BULLETIN NUMBER:
SB19-J-002

Evaporative Emission (EVAP) Canister Vent Solenoid Valve Relocation

AFFECTED VEHICLES

- 2012 – 2019MY Isuzu N-Series Vehicles Built Prior to 1/30/2019 and Equipped with 6.0L Gasoline Engines

Figure 1

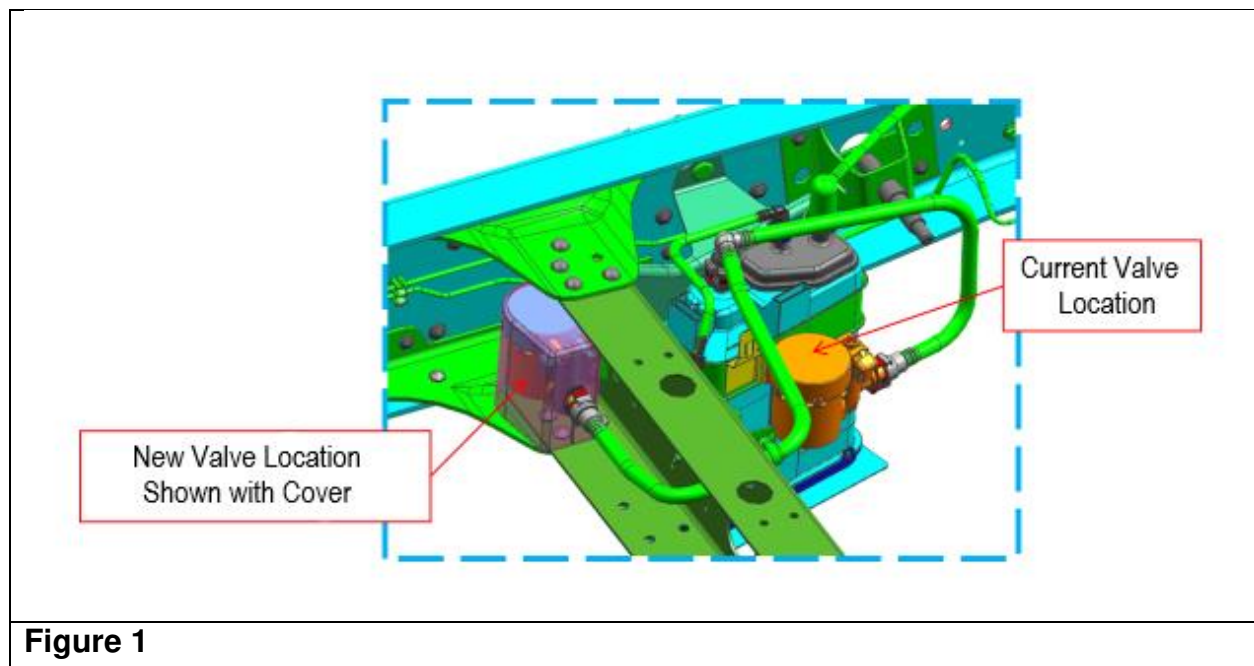
Some customers whose vehicles are operated in dusty type environments, such as farming, sweeping, or off-road type applications, may comment about the illumination of the check engine light, with one or more of the following DTC's set: P0449 (Evaporative Emission Vent Solenoid Valve Control Circuit Low Voltage), P0446 (Evaporative Emission Vent System Performance) and P0455 (Evaporative Emission System Large Leak Detected). Dirt and dust intrusion into the EVAP canister vent solenoid valve may cause this condition. If normal diagnostics for any of the above DTCs determines the Evaporative Emission (EVAP) canister vent solenoid valve has failed, replace the existing EVAP canister vent solenoid valve (the "Valve") with a new assembly. Then cover the valve and relocate it with updated parts using the service procedure in this bulletin. (See Figure 1.)

Figure 3

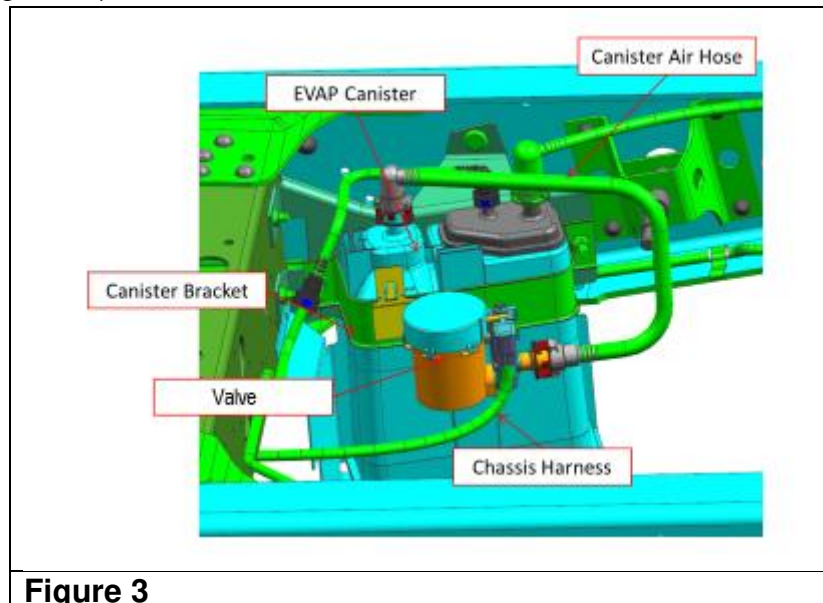
2. Disconnect the Canister Air Hose from the Canister Assembly and the Valve. (See Figure 3.) Discard the hose.

Figure 6

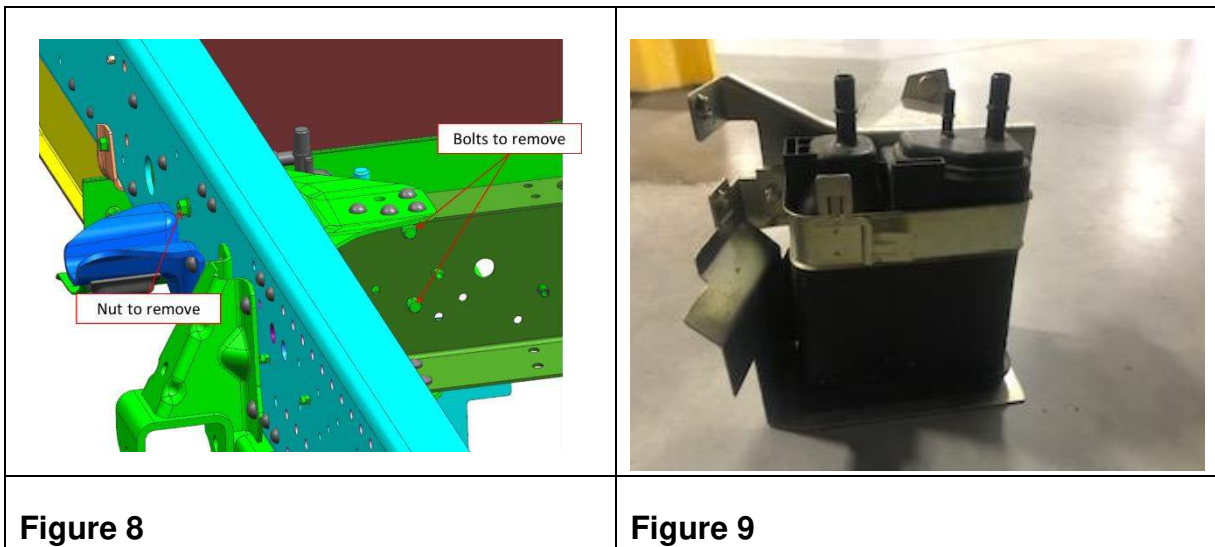
5. Disconnect the Fuel Tank Vapor Pipe from the EVAP Canister. (See Figure 6.)

Figure 7

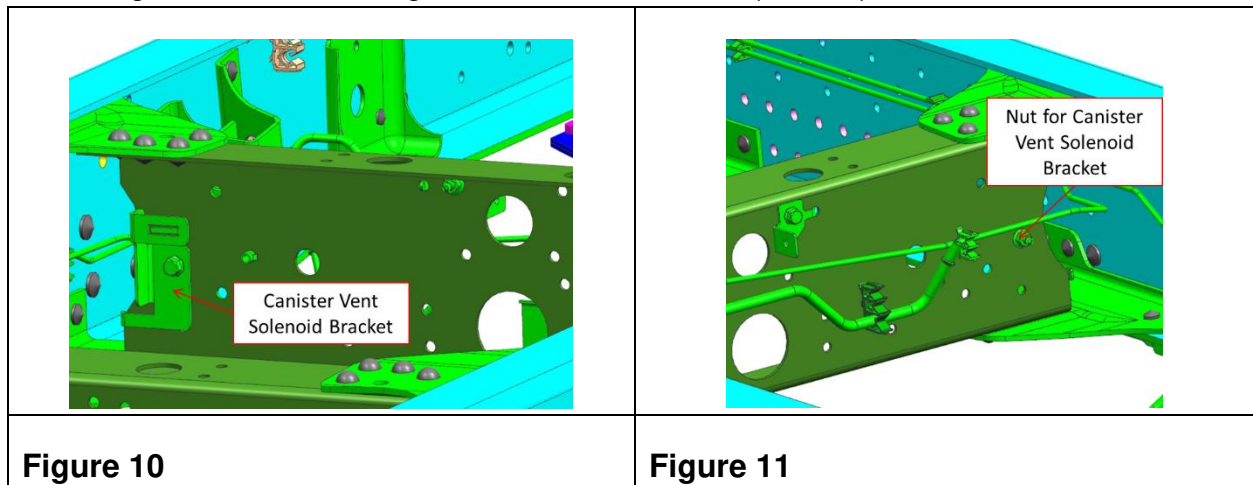
6. Disconnect the Purge Hose at the EVAP Canister. (See Figure 7.)

Figure 15

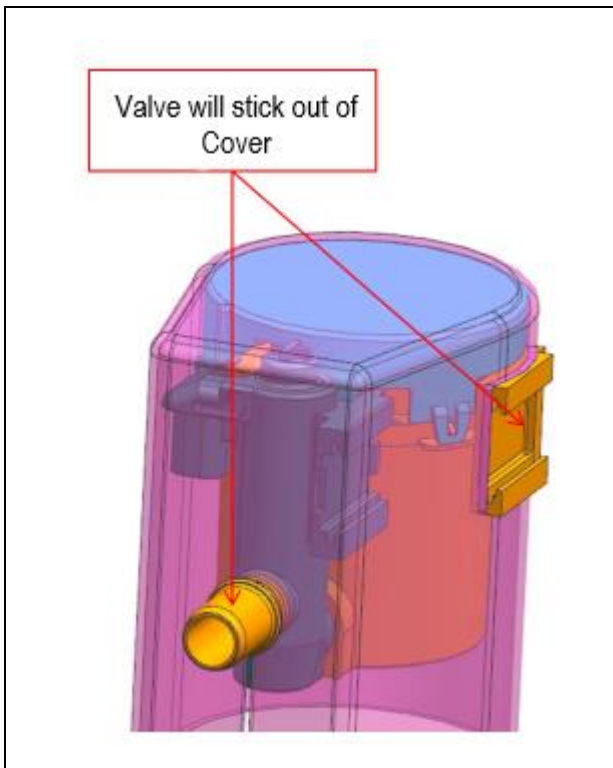
11. Route the Chassis Harness Valve connector to the rear of the cross member and connect it to the new Valve. Place the new Valve into the Cover as shown in Figures 15 and 16. Note that the Valve Bracket attachment point and the Canister Air Hose Port will stick out of the cover.

Figure 17

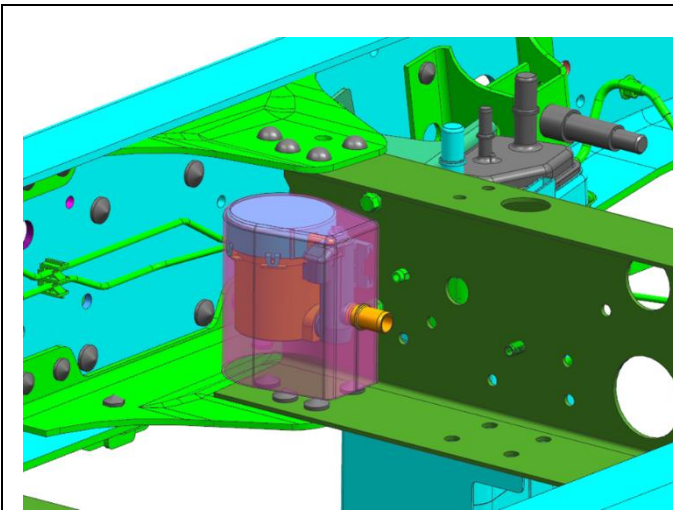
12. Using the attachment point on the Valve, mount the Valve and Cover assembly to the new Bracket as shown in Figures 17 and 18.

Figure 19

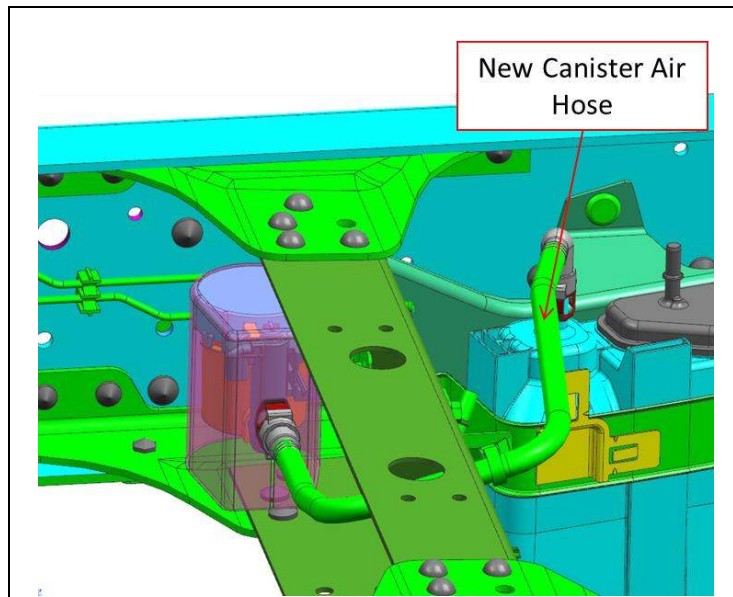
13. Route the new Canister Air Hose from the Valve Port to the Canister Port as shown in Figure 19.
